Client:
MR. & MRS. HUNT
Project:
THORNBY FARM
STOWING
KENT
TN25 6BA
Title:

Elevations as Proposed

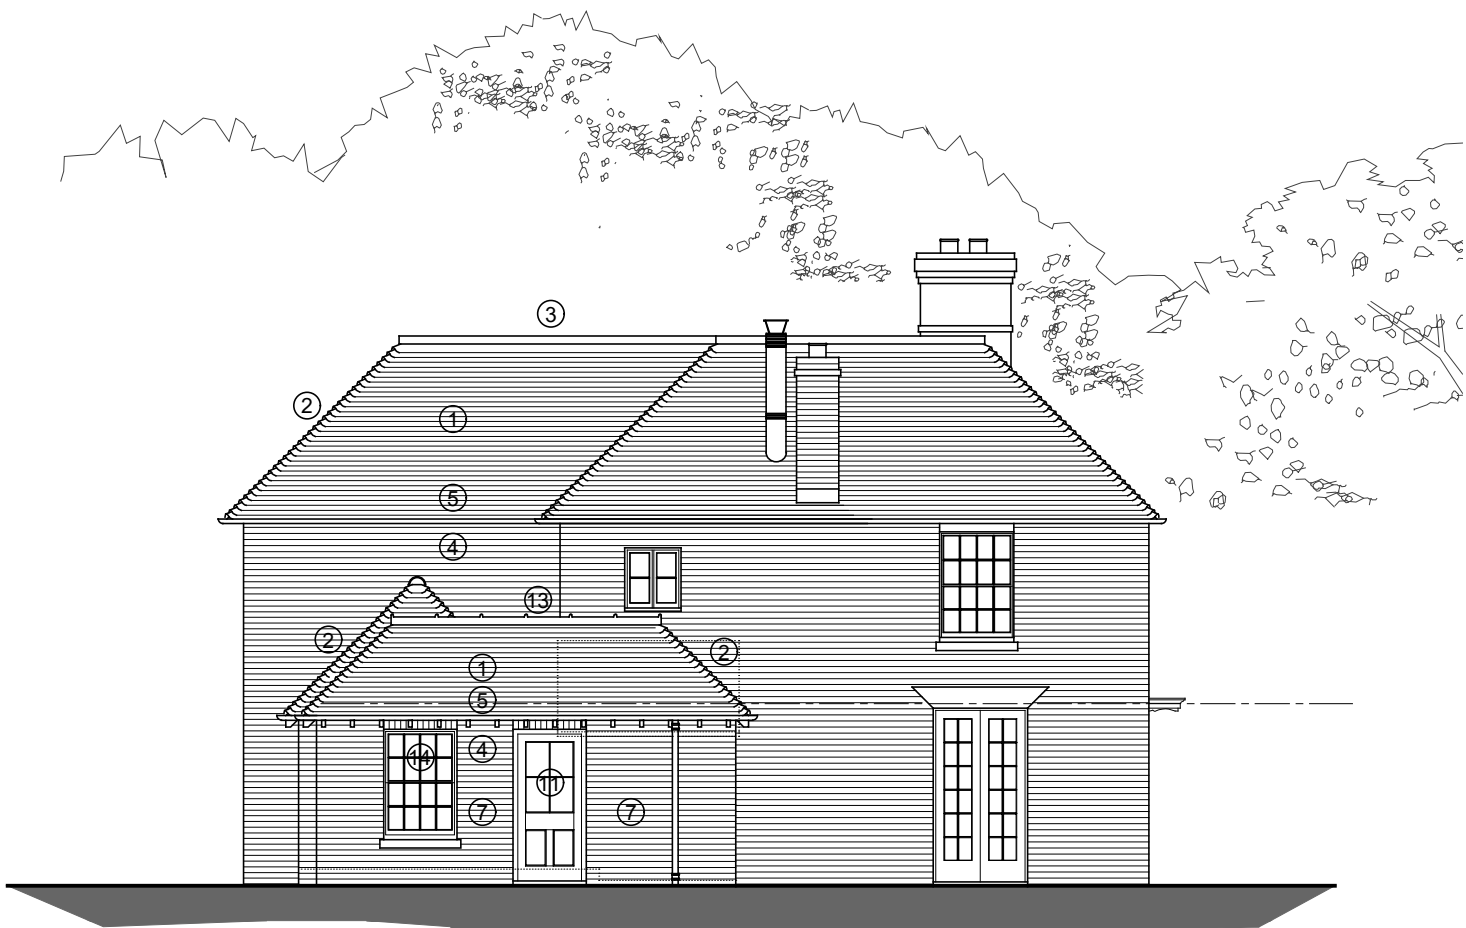
P4	updated to Conservation Officer's comments dated 02.01.2020: new external door design revised, additional window added to rear elevation serving living area to hide demolition scar. kitchen and boot room roof design revised and eaves height lowered	28.01.2020
P3	orangery omitted, store extension added to form boot room	24.09.2019
P2	updated to Conservation Officer's comments: window spacing adjusted to 2 storey extension. glazing redesigned to kitchen and rooflights repositioned, kitchen and orangery roof redesigned, orangery external wall set back 110mm. openings within rear wall reduced	16.09.2019
P1	two storey extension lengthened by 300mm	06.04.2019
Revision:	Description:	Date:
